Room 107  
 Electrical Changes  
 3/9/90 WPH

**MARYLAND INSTITUTE**

**FIRST FLOOR PLAN**  
 Contract Pkg.

FIRST FLOOR PLAN  
 SCALE: 1/4" = 1'-0"

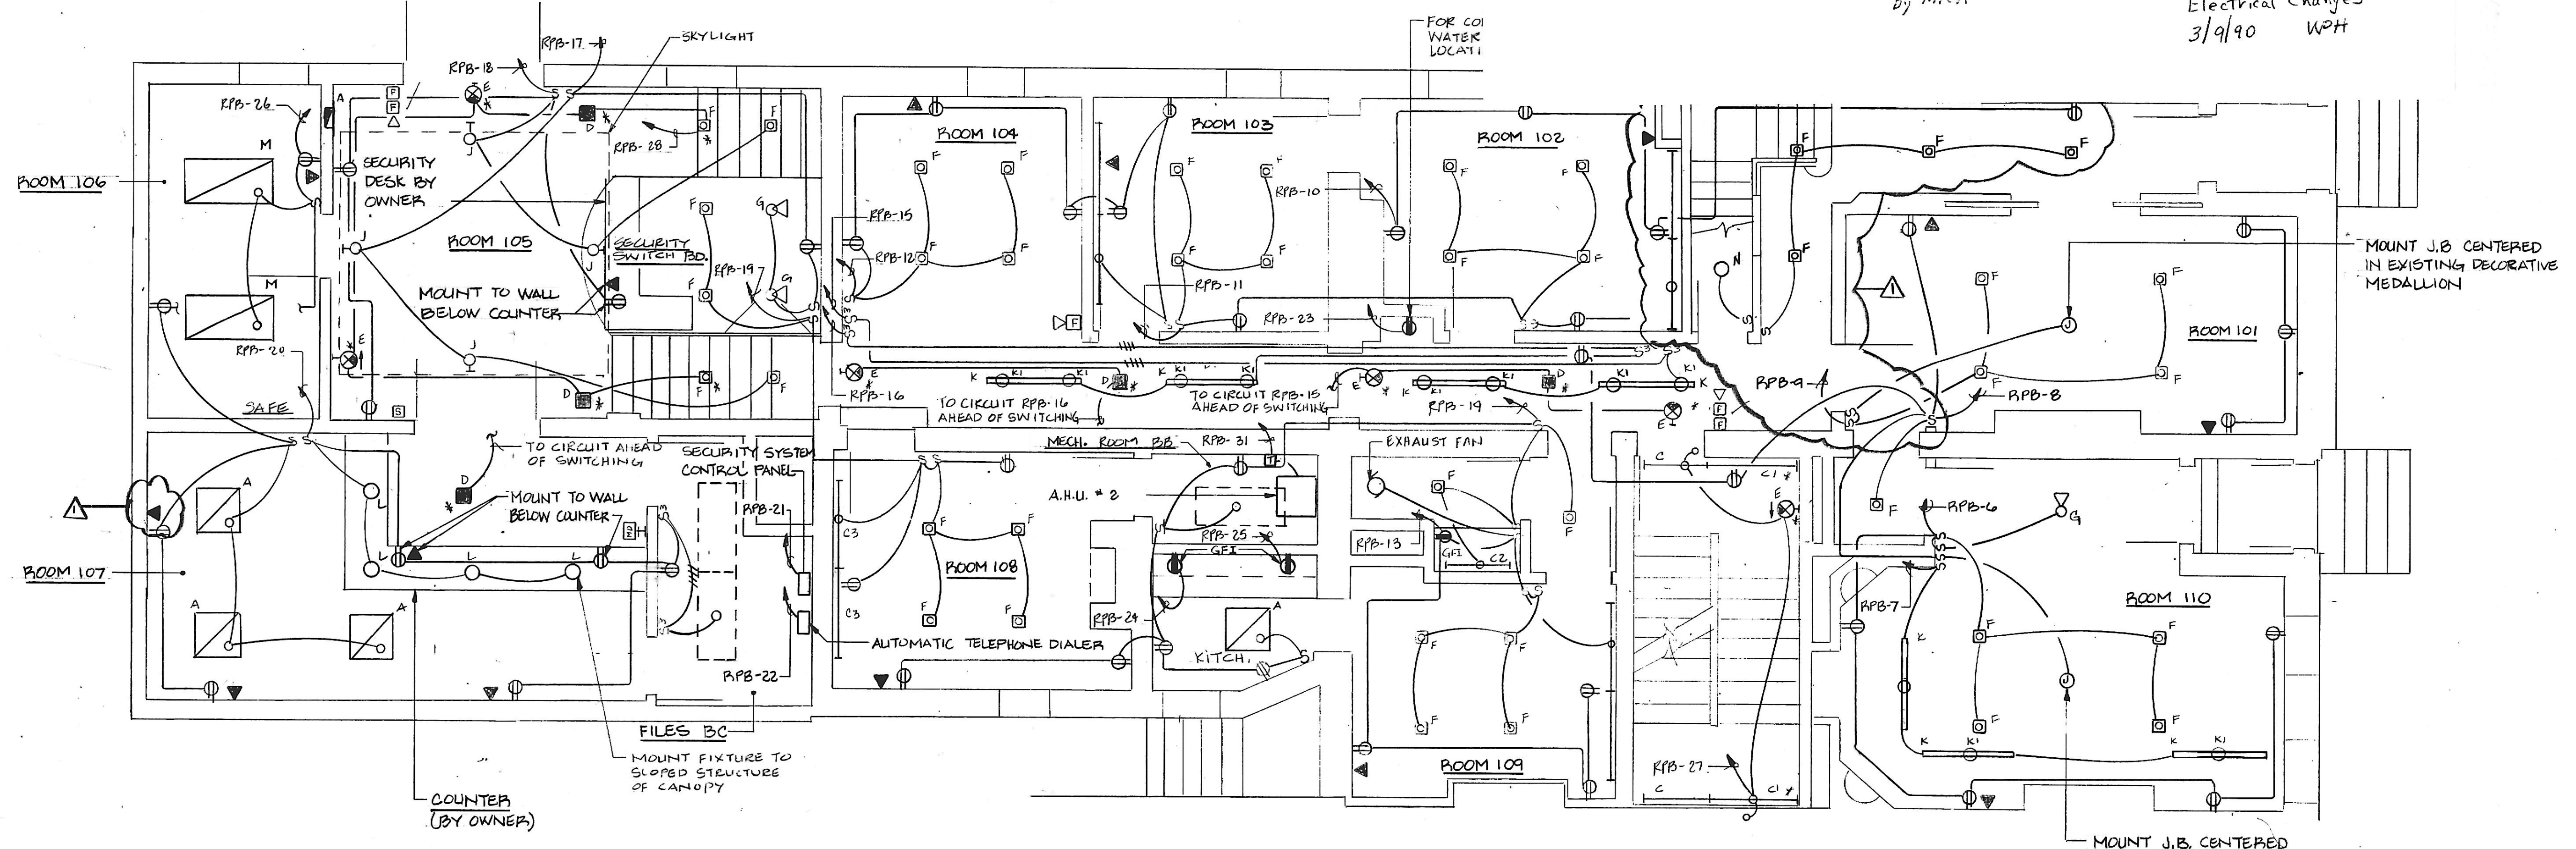
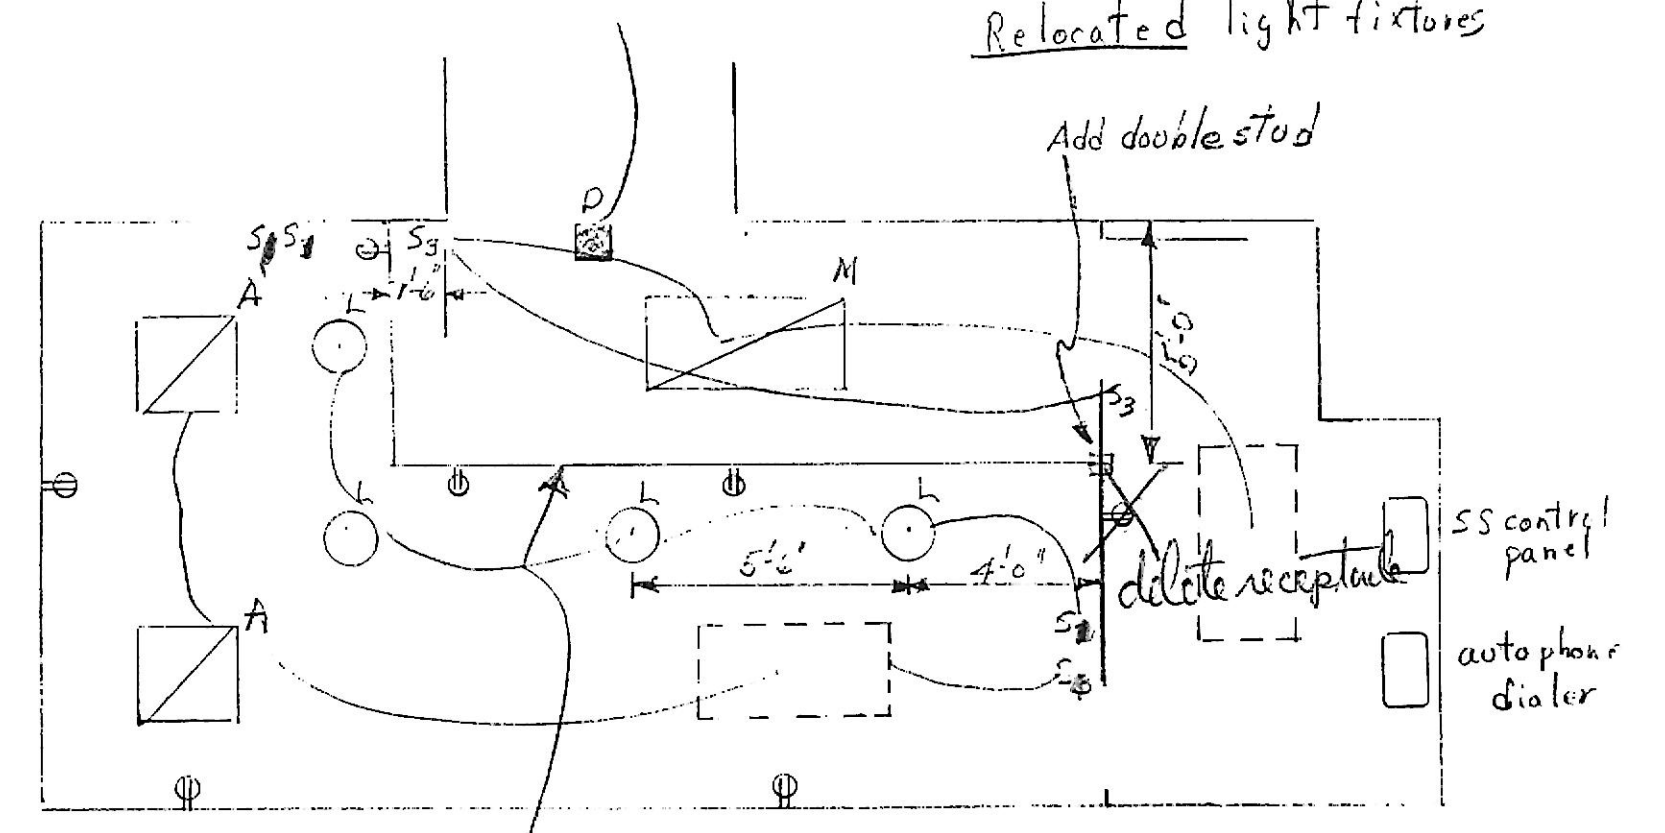
Added  
 1 - duplex receptacle  
 1 - 2x4 fluorescent fixture  
 Deleted  
 1 - 2x2 fluorescent fixture  
 Relocated light fixture
